Appendix C

Agency Coordination

RE: SH 82/Grand Avenue Bridge Environmental Assessment

RE: Grand Avenue Bridge Environmental Assessment

Figure 2 - Temporary and Permanent Easements

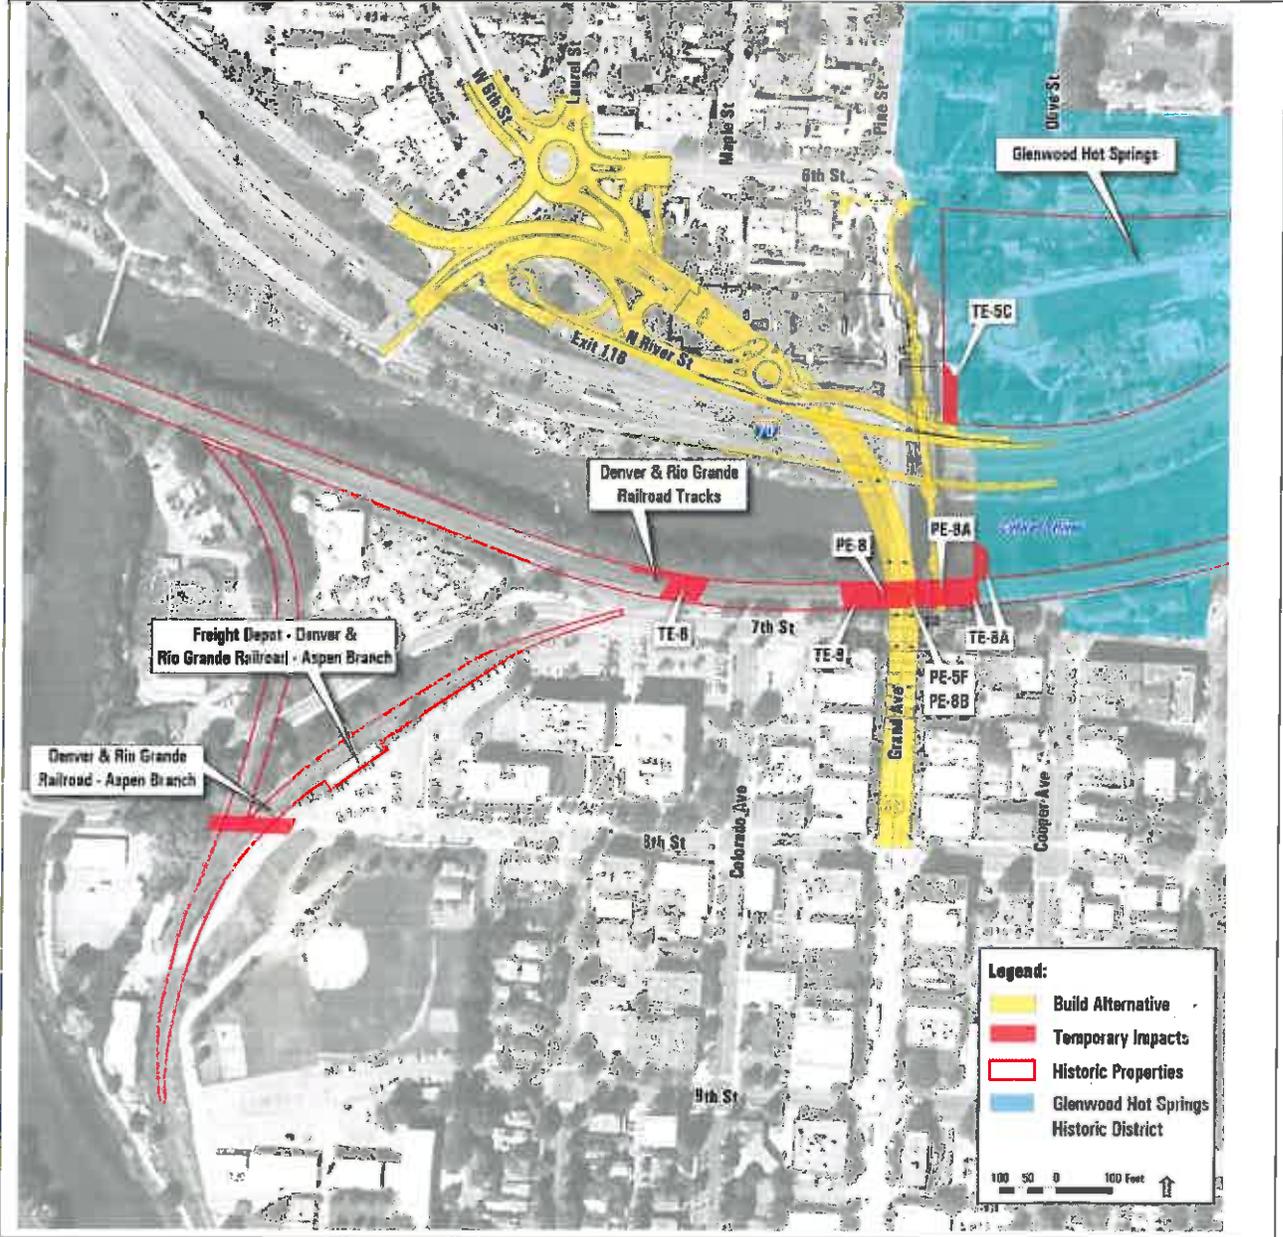
Denver & Rio Grande Railroad (5GF1000.7): In the April 2014 consultation, there was a single permanent aerial easement (0.01 acre) to the railroad. Also, the August 2014 consultation described a temporary aerial easement to the railroad. However, based on updated right-of-way information, neither of these easements would be considered "aerial." This does not change the effects; impacts in locations previously designated as aerial would still be limited to above-ground work. Further, our April 2014 consultation stated that three temporary easements totaling approximately 0.15 acre would be required on the railroad west of the bridges. Now only two temporary easements are required west of the bridges, and total approximately 0.21 acre. The use of these easements is the same as described in our previous consultation, which is to provide access to construction areas.

Three additional permanent easements will be required on the railroad that were not included in the previous consultation. One area is approximately 0.115 acre located under the existing highway bridge. Although this involves one area, a permanent easement is required from the two parties disputing property ownership, resulting in two permanent easements for this one area. The third permanent easement is approximately 0.037 acre located under the existing pedestrian bridge. These three permanent easements are needed to provide access to CDOT for ongoing bridge maintenance. In summary, there are now a total of four permanent easements (including two permanent easements for one area) and three temporary easement locations on the railroad, as noted in Table 1. These permanent and temporary easements will

Modifications made to permanent and temporary easements for 5GF1050, 5GF1050.2 and 5GF1000.7 described in Table 1 are minor, and the project would still result in *no adverse effect* to these resources. Easements listed in Table 1 are shown on Figure 2.

Figure 1 - Modified Area of Potential Effect and 5GF1661.7 boundary

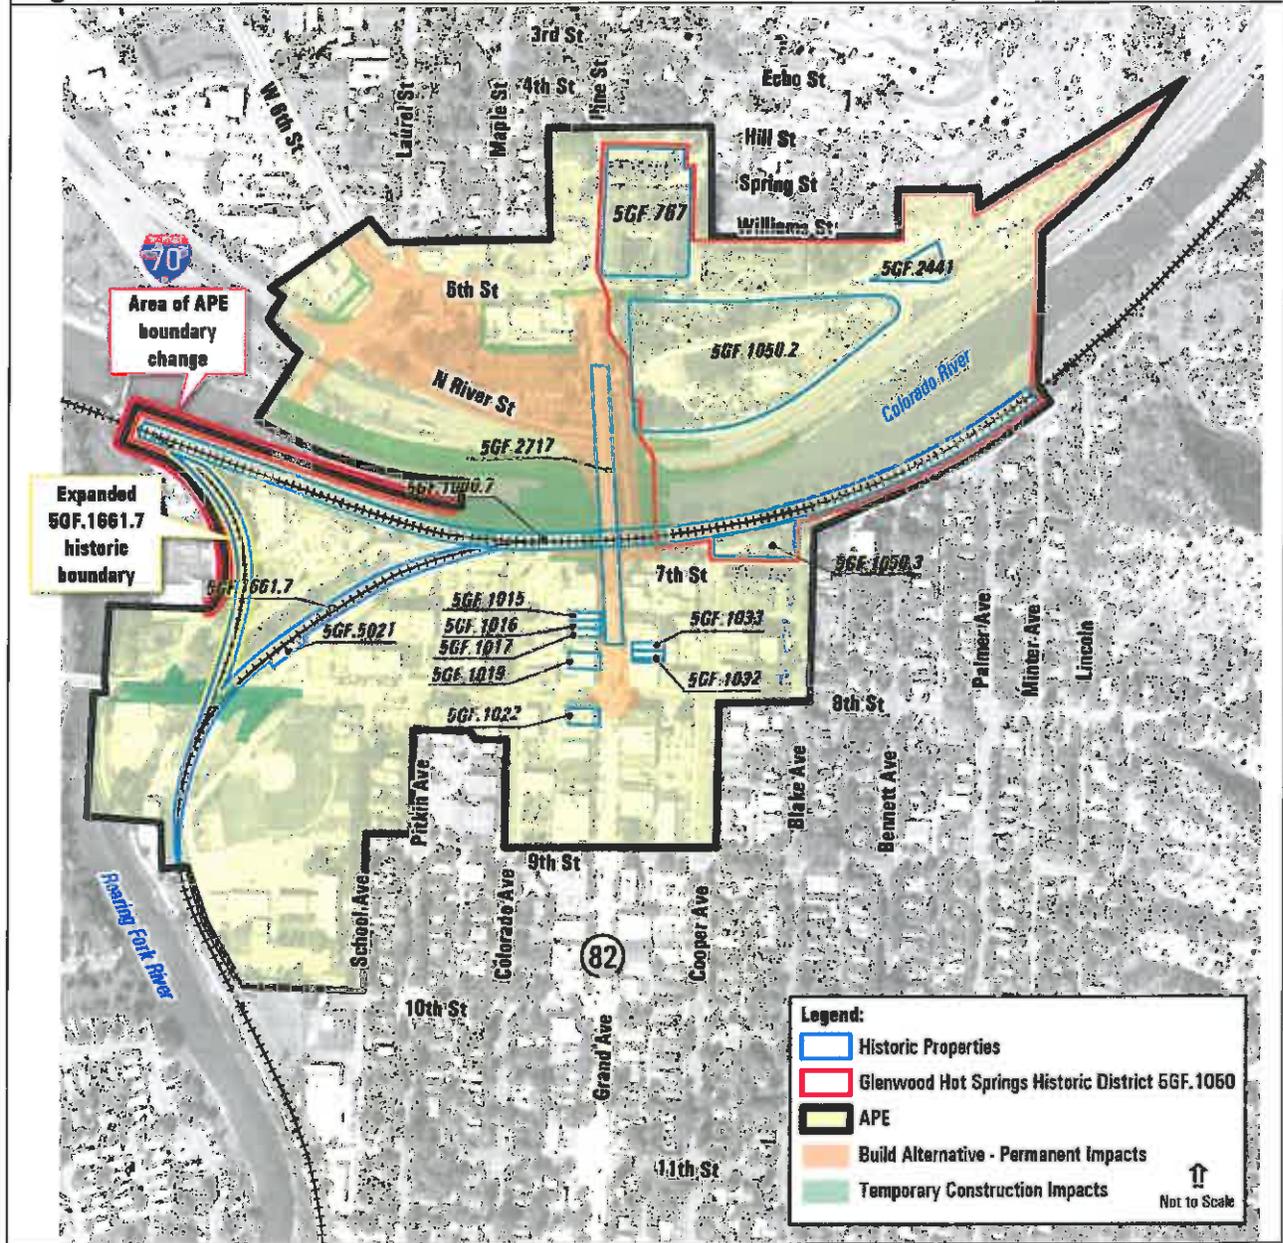
The APE boundary outlined in our March 2014 letter has been extended to the west to fully encompass the historic boundary for the Denver & Rio Grande Railroad (5GF1000.7). This revision was included in the Environmental Assessment (EA) without formal consultation with SHPO and the consulting parties, but the change is minor and involves including a part of the documented resource that was previously excluded from the boundary. The APE boundary was also revised to encompass the extended historic boundary for the Denver & Rio Grande Railroad-Aspen Branch (5GF1661.7). With this change, the APE now encompasses the area east of the resource that was not previously included. This area will not be impacted by the project, but is included in the APE to allow for a contiguous APE boundary. The area contains the City of Glenwood Springs' former wastewater treatment plant, which is planned for redevelopment. A revised APE map is included herewith, and the updated areas are highlighted.

To be consistent with the revised APE, the historic boundary for the Denver & Rio Grande Railroad-Aspen Branch (5GF1661.7) was modified to better reflect the resource description on the site form that includes the connection to the westbound Denver & Rio Grande Railroad mainline. The updated site form and maps for that resource are attached.

Figure 2 - Temporary and Permanent Easements

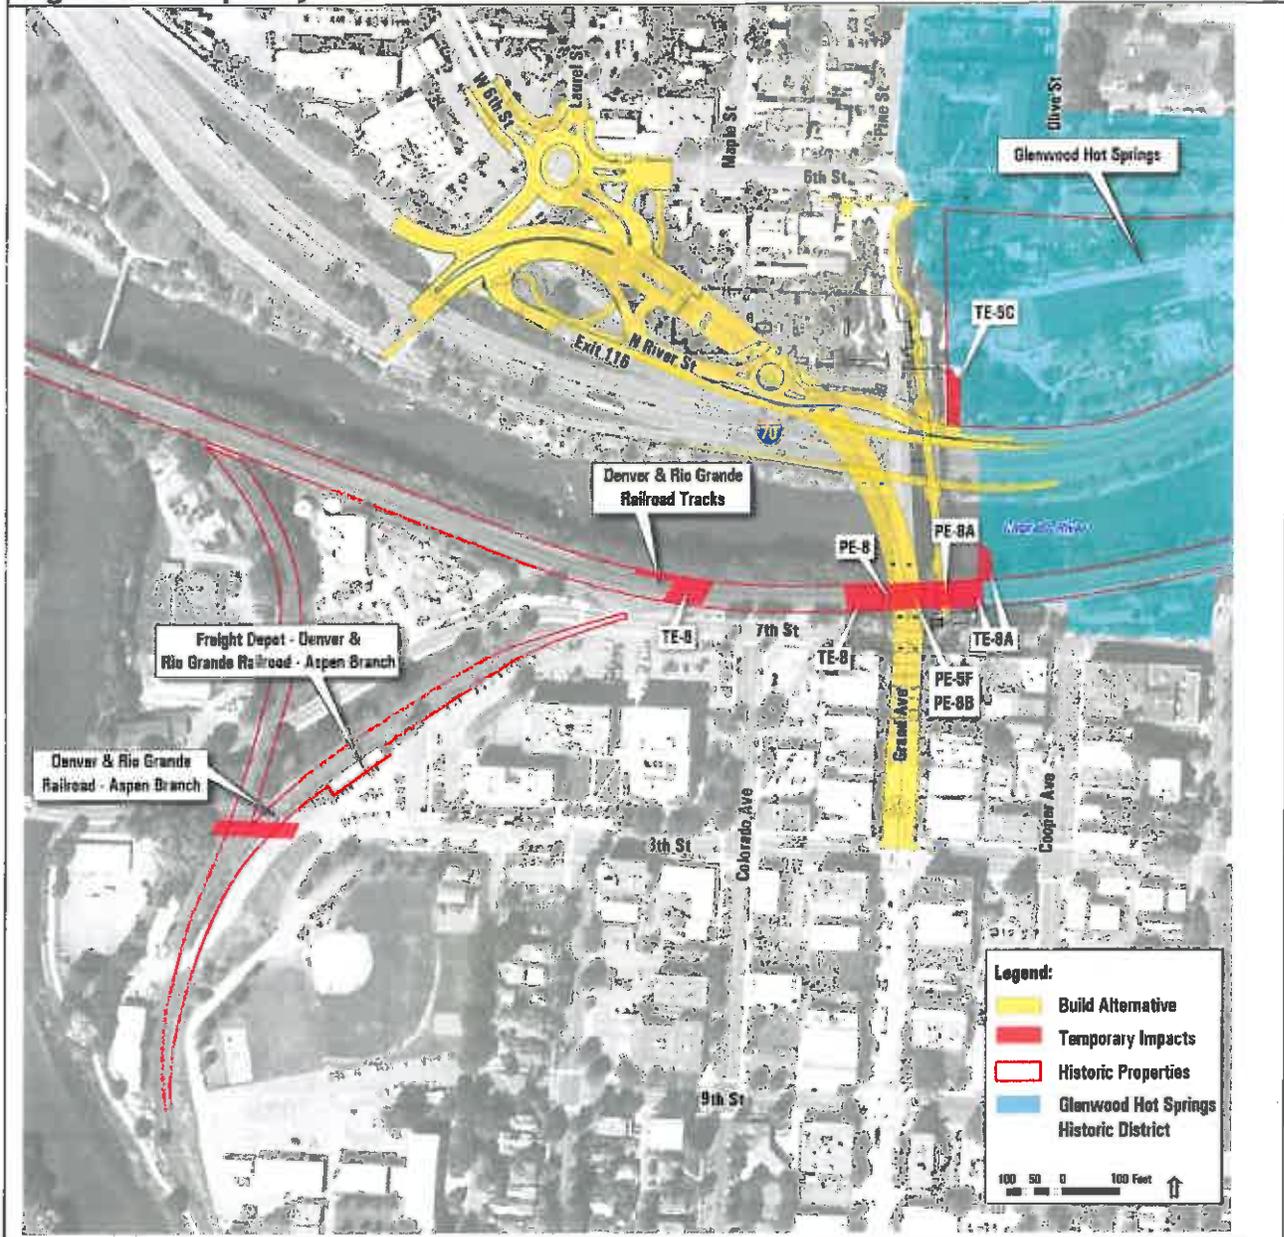
Denver & Rio Grande Railroad (5GF1000.7): In the April 2014 consultation, there was a single permanent aerial easement (0.01 acre) to the railroad. Also, the August 2014 consultation described a temporary aerial easement to the railroad. However, based on updated right-of-way information, neither of these easements would be considered "aerial." This does not change the effects; impacts in locations previously designated as aerial would still be limited to above-ground work. Further, our April 2014 consultation stated that three temporary easements totaling approximately 0.15 acre would be required on the railroad west of the bridges. Now only two temporary easements are required west of the bridges, and total approximately 0.21 acre. The use of these easements is the same as described in our previous consultation, which is to provide access to construction areas.

Three additional permanent easements will be required on the railroad that were not included in the previous consultation. One area is approximately 0.115 acre located under the existing highway bridge. Although this involves one area, a permanent easement is required from the two parties disputing property ownership, resulting in two permanent easements for this one area. The third permanent easement is approximately 0.037 acre located under the existing pedestrian bridge. These three permanent easements are needed to provide access to CDOT for ongoing bridge maintenance. In summary, there are now a total of four permanent easements (including two permanent easements for one area) and three temporary easement locations on the railroad, as noted in Table 1. These permanent and temporary easements will

Modifications made to permanent and temporary easements for 5GF1050, 5GF1050.2 and 5GF1000.7 described in Table 1 are minor, and the project would still result in *no adverse effect* to these resources. Easements listed in Table 1 are shown on Figure 2.

Figure 1 - Modified Area of Potential Effect and 5GF1661.7 boundary

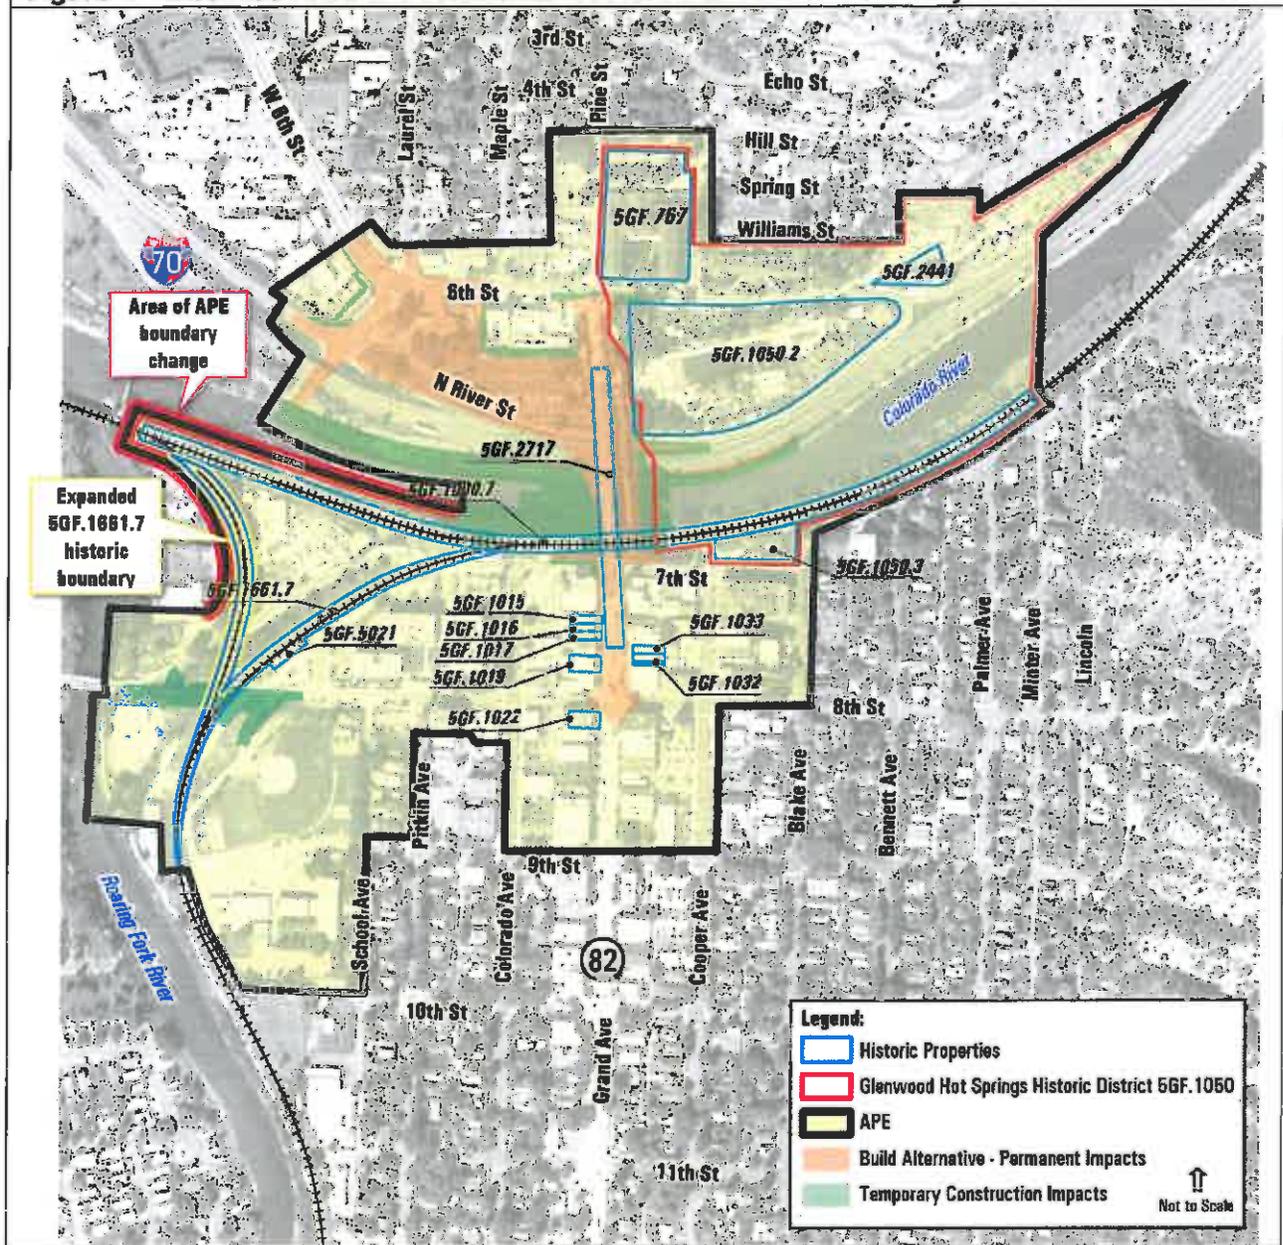
The APE boundary outlined in our March 2014 letter has been extended to the west to fully encompass the historic boundary for the Denver & Rio Grande Railroad (5GF1000.7). This revision was included in the Environmental Assessment (EA) without formal consultation with SHPO and the consulting parties, but the change is minor and involves including a part of the documented resource that was previously excluded from the boundary. The APE boundary was also revised to encompass the extended historic boundary for the Denver & Rio Grande Railroad-Aspen Branch (5GF1661.7). With this change, the APE now encompasses the area east of the resource that was not previously included. This area will not be impacted by the project, but is included in the APE to allow for a contiguous APE boundary. The area contains the City of Glenwood Springs' former wastewater treatment plant, which is planned for redevelopment. A revised APE map is included herewith, and the updated areas are highlighted.

To be consistent with the revised APE, the historic boundary for the Denver & Rio Grande Railroad-Aspen Branch (5GF1661.7) was modified to better reflect the resource description on the site form that includes the connection to the westbound Denver & Rio Grande Railroad mainline. The updated site form and maps for that resource are attached.

Figure 2 - Temporary and Permanent Easements

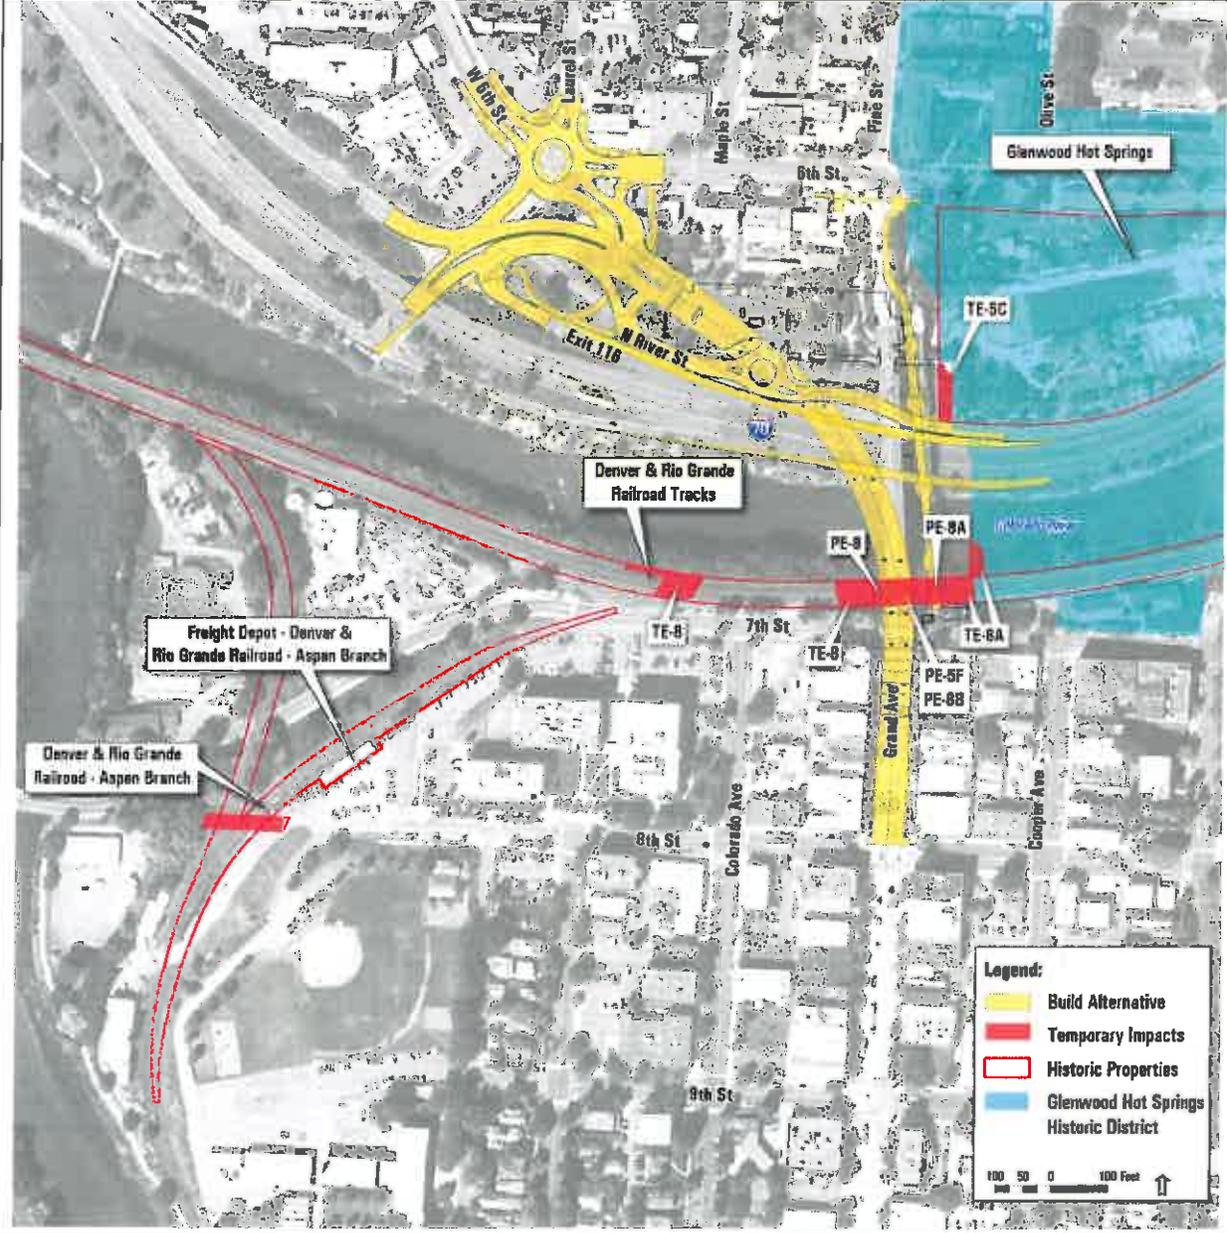
Denver & Rio Grande Railroad (5GF1000.7): In the April 2014 consultation, there was a single permanent aerial easement (0.01 acre) to the railroad. Also, the August 2014 consultation described a temporary aerial easement to the railroad. However, based on updated right-of-way information, neither of these easements would be considered "aerial." This does not change the effects; impacts in locations previously designated as aerial would still be limited to above-ground work. Further, our April 2014 consultation stated that three temporary easements totaling approximately 0.15 acre would be required on the railroad west of the bridges. Now only two temporary easements are required west of the bridges, and total approximately 0.21 acre. The use of these easements is the same as described in our previous consultation, which is to provide access to construction areas.

Three additional permanent easements will be required on the railroad that were not included in the previous consultation. One area is approximately 0.115 acre located under the existing highway bridge. Although this involves one area, a permanent easement is required from the two parties disputing property ownership, resulting in two permanent easements for this one area. The third permanent easement is approximately 0.037 acre located under the existing pedestrian bridge. These three permanent easements are needed to provide access to CDOT for ongoing bridge maintenance. In summary, there are now a total of four permanent easements (including two permanent easements for one area) and three temporary easement locations on the railroad, as noted in Table 1. These permanent and temporary easements will

Modifications made to permanent and temporary easements for 5GF1050, 5GF1050.2 and 5GF1000.7 described in Table 1 are minor, and the project would still result in *no adverse effect* to these resources. Easements listed in Table 1 are shown on Figure 2.
